**RESPONSE TO THE DEFICIENCIES IDENTIFIED BY THE OHIO  
ENVIRONMENTAL PROTECTION AGENCY AFTER REVIEW OF URANYL  
NITRATE HEXAHYDRATE TANK SYSTEM**

**DOE-2386-94  
DOE-FN            OEPA  
18  
RESPONSE**

DOE-2386-94

**RESPONSE TO THE DEFICIENCIES IDENTIFIED BY THE OHIO ENVIRONMENTAL PROTECTION AGENCY AFTER REVIEW OF THE URANYL NITRATE HEXAHYDRATE TANK SYSTEM**

HWMU # 50 (Location 1)  
HOT REFRACTORY DIKE AREAS F1-301, 302 + 303

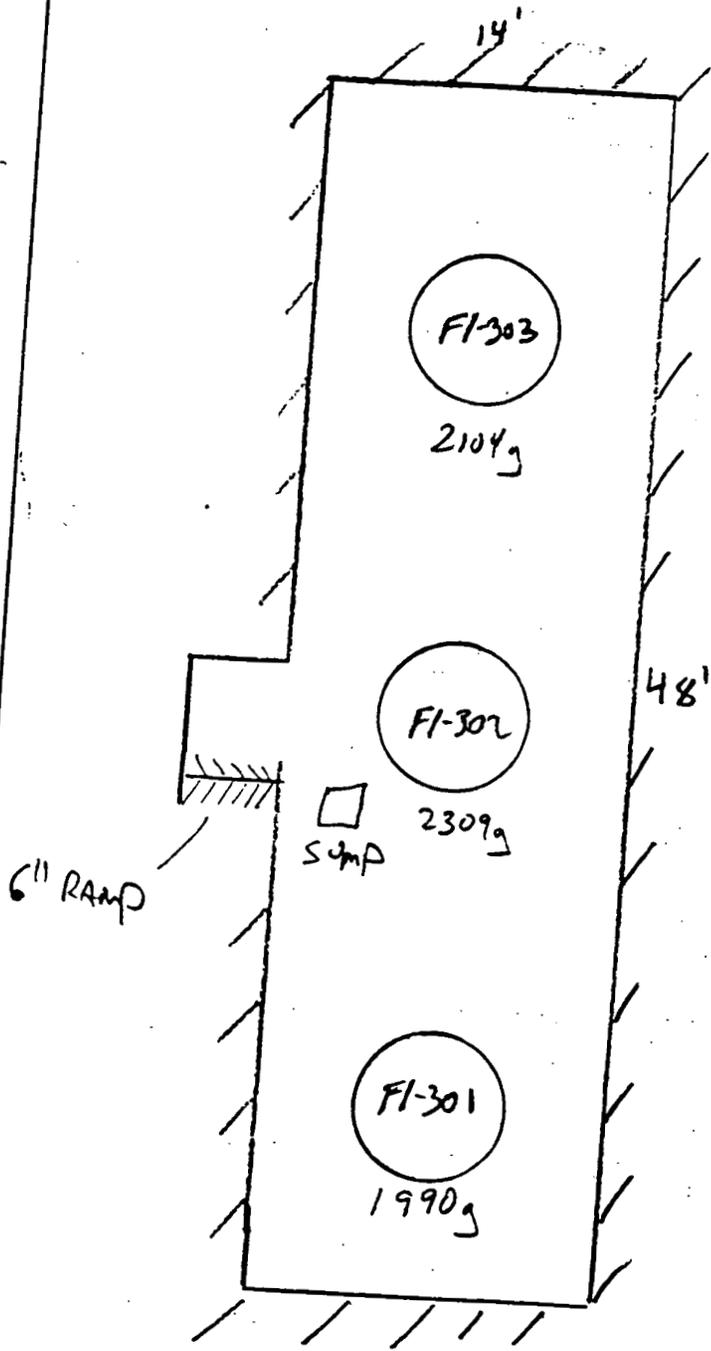
Enclosed are calculations providing documentation to support the volume capacity for the Hot Raffinate area. The Hot Raffinate area has two separate containment areas. Tanks F1-301, F1-302, and F1-303 are contained in one area and Tank F1-308 is housed in the second area.

$Sa\ Ft = 14' \times 48' = 672\ Ft^2$

Are DiKe Depth 7"  $\Rightarrow 392\ Ft^3$

$392 - 309 = 83\ Ft^3$   
EXCESS

44 Ft<sup>3</sup> Safety Margin  
(329 g+)
